**Informal Ad hoc Expert Group on Conceptual and  
Technical Aspects of Computerization of the TIR Procedure**

**Twenty-ninth session**

**eTIR conceptual, functional and technical documentation**

## **Approved amendments to the eTIR conceptual, functional and technical documentation - v.4.2a**

Figure 3  
**Guarantee status chart diagram**

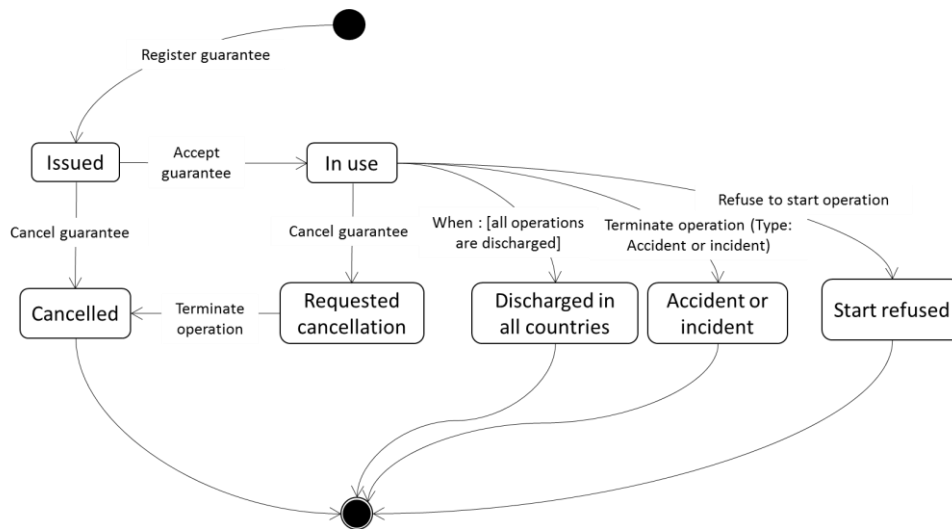
6. Chapter “3.1.2 Guarantee state chart diagram” of the eTIR concepts document will list the two additional guarantee statuses.

7. Figure 3 in the same document will be amended as follows:

### a. Message sequence for countries of departure

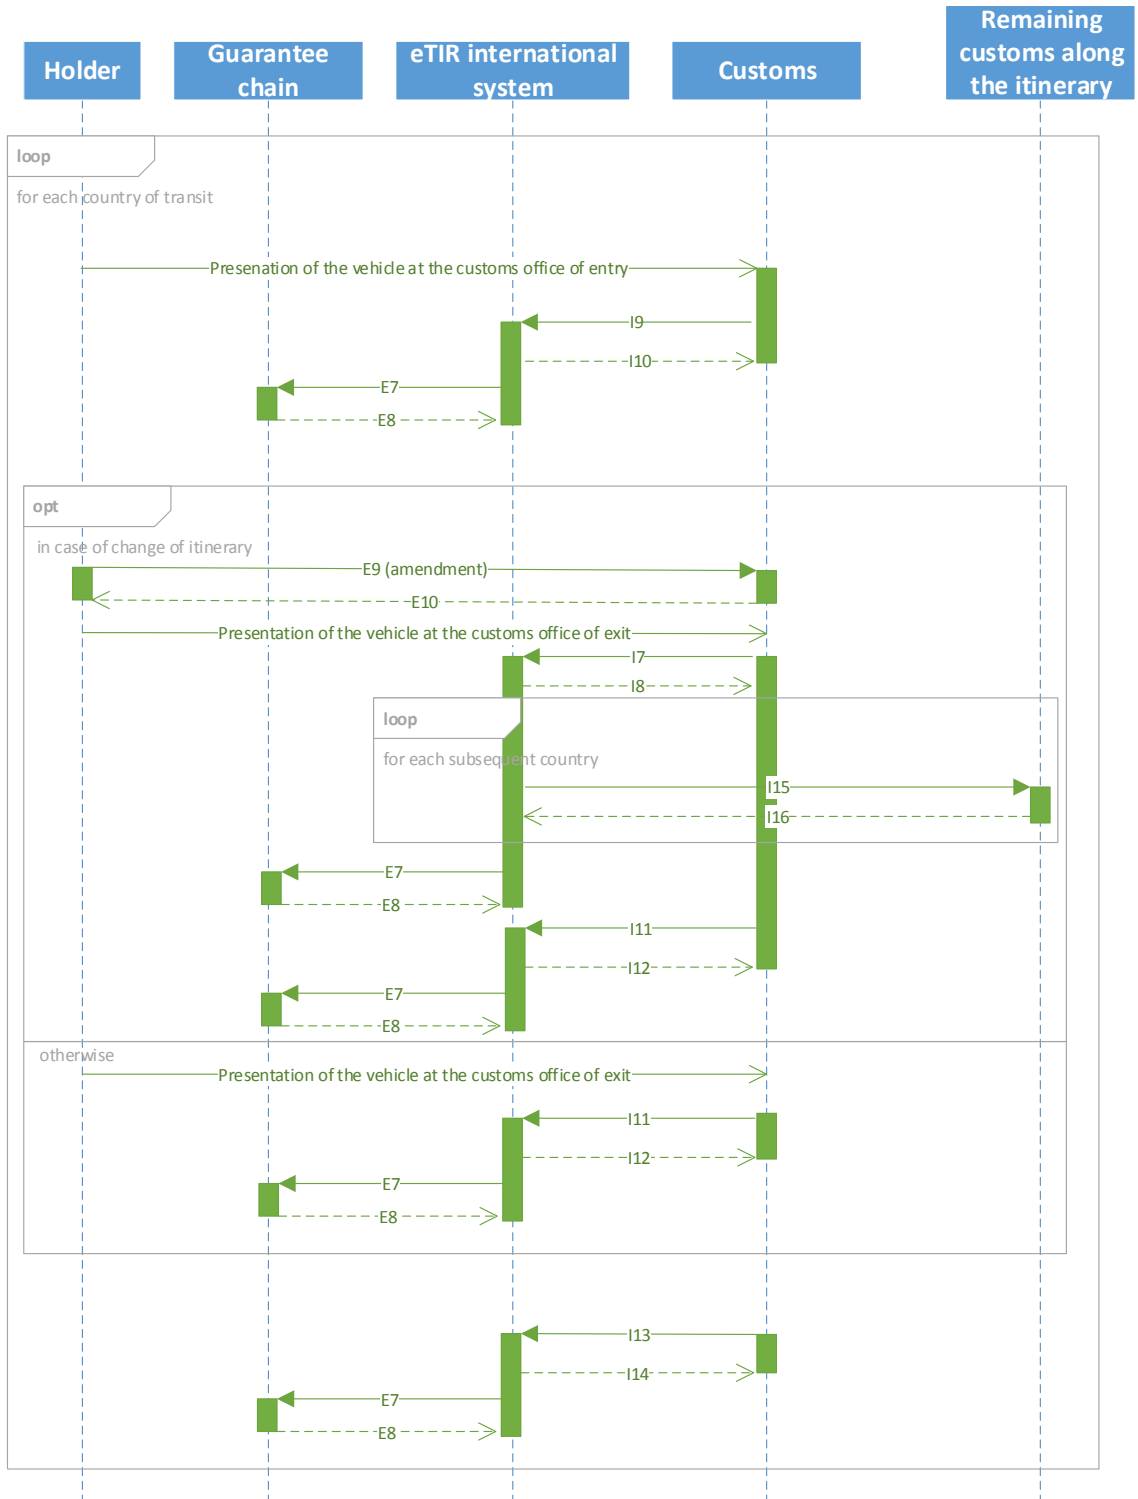
3. The sequence diagrams describing the standard sequences of eTIR messages for countries of departure, transit and destination (as contained in Annex) will be included in the next revision of the eTIR functional specifications as a new Annex.
